LOCAL PLANNING PANEL AGENDA

LIVERPOOL
CITY
COUNCIL

ITEM No.	SUBJECT	PAGE No.
1	<p>DEVELOPMENT APPLICATION DA-435/2025</p> <p>DEMOLITION OF EXISTING STRUCTURES AND STAGED SUBDIVISION OF TWO EXISTING ALLOTMENTS INTO A TORRENS TITLE SUBDIVISION OF 102 RESIDENTIAL LOTS IN TWO (2) STAGES AND CONSTRUCTION OF ROADS AND ASSOCIATED CIVIL WORKS, INCLUDING DRAINAGE DISCHARGE OVER COUNCIL OWNED LAND AND INTO A CREEK.</p> <p>THE STAGING IS AS FOLLOWS: STAGE 1 - SUBDIVISION INTO 80 TORRENS TITLE LOTS, BEING 79 RESIDENTIAL LOTS AND ONE RESIDUE LOT (LOT 80), CREATION OF ROADS AND DRAINAGE, CIVIL WORKS, AND DEMOLITION OF EXISTING DWELLINGS AND OUTBUILDINGS. STAGE 2 - SUBDIVISION OF RESIDUE LOT 80 (FROM STAGE 1) INTO 23 TORRENS TITLE RESIDENTIAL LOTS</p> <p>THE PROPOSAL IS IDENTIFIED AS INTEGRATED DEVELOPMENT REQUIRING APPROVAL FROM NSW RURAL FIRE SERVICES UNDER THE RURAL FIRES ACT 1997.</p> <p>THE APPLICATION IS NOMINATED INTEGRATED DEVELOPMENT REQUIRING APPROVAL FROM THE DPE - WATER UNDER THE WATER MANAGEMENT ACT 2000.</p> <p>LOT 20, SECTION 1, DEPOSITED PLAN 2756, LOT 2 DEPOSITED PLAN 1305255 & LOT 1 DEPOSITED PLAN 1305225 – 10 KELLY STREET</p> <p>4, 6 & 10 KELLY STREET, AUSTRAL</p>	5 - 66

ITE

Figure 18: Biodiversity Values Map (Source: NSW Planning Portal Spatial Viewer)

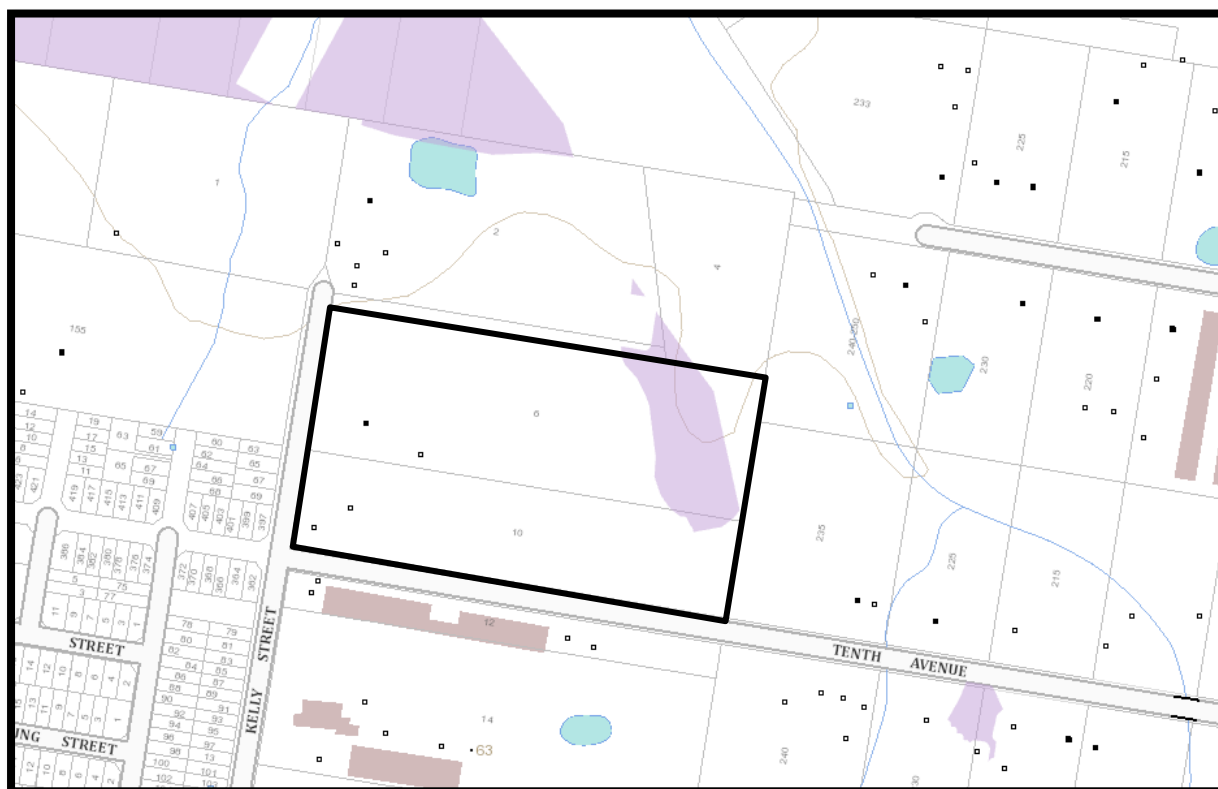
It was also observed that the BDAR referenced an outdated engineering design which sought to drain using the existing tailout drain on the land to the north. The submitted engineering design introduced a pipe along the northern boundary, which is neither referenced nor assessed in the submitted BDAR.

The above was raised in the request for additional information. As no formal response was submitted, matters of biodiversity assessment are unresolved, and the application is recommended for refusal.

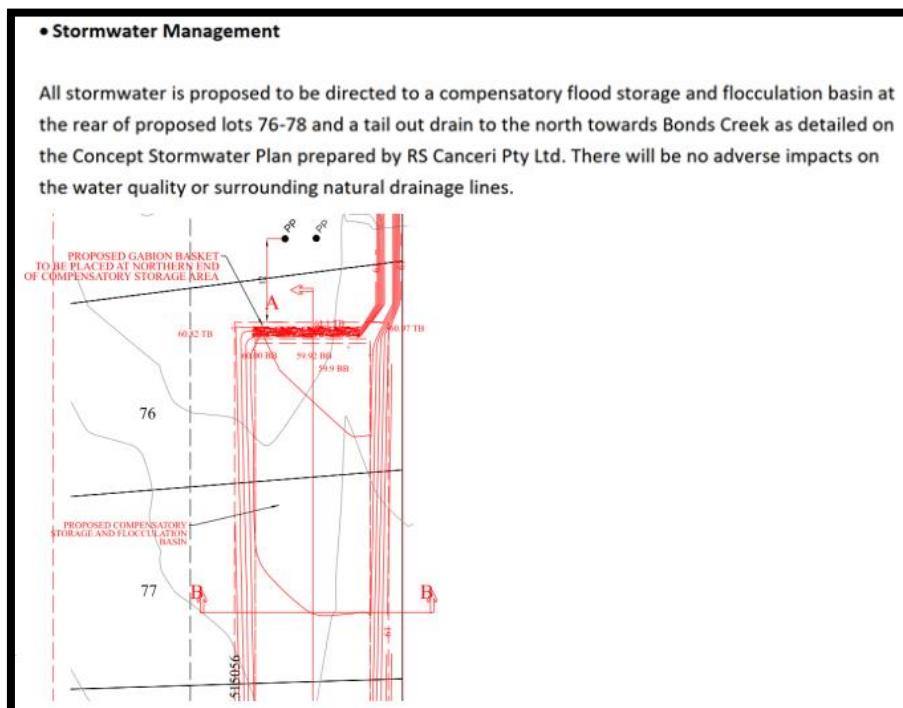
The following extract of Endeavour Energy's HxGN NetWorks Core Master Facility shows two proposed new poles to move the existing H-Pole structures 63Y and 63X (indicated as by the colouring as 'Proposed removed') – likely required to rectify low clearance and maintain the required feeder rating. As the basin is almost the full width of the easement, it may impact the duplication plans.

Accordingly the location of the proposed basin requires further investigation and / or confirmations that the new poles are not impacted. The proposed residential lots do not get close enough to impact the plans to duplicate the feeder.”

Figure 26: Extract of the Southwest Corner of Stage 1 Engineering Plans (Source: R. S. Canceri)

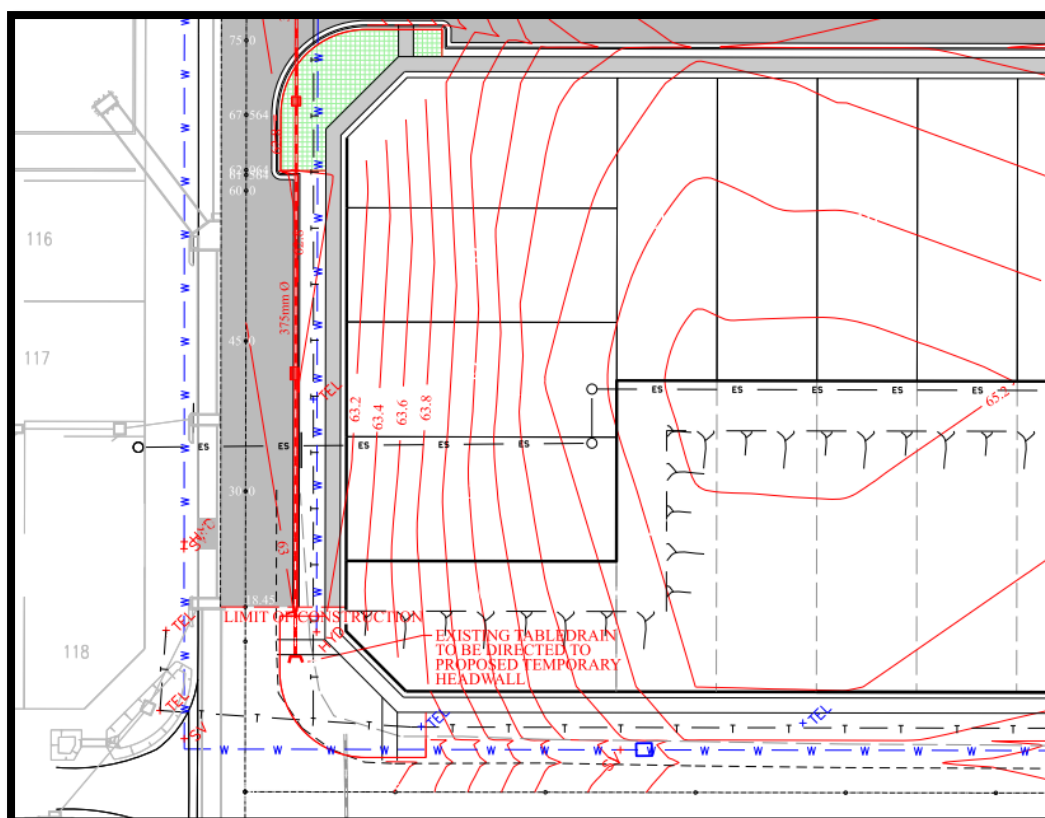
The proposed levels will create a number of sloping lots, whereas the site is generally flat. In particular, the lots fronting Kelly Street in the southwestern part of the site will fall approximately 1.8m from rear to street and up to 1.2m on other lots fronting Kelly Street. Refer to the extract of the engineering plans below.

A detailed description and explanation for the degree of fill was not submitted with the application. It has not been established in the application that the degree of fill is necessary.
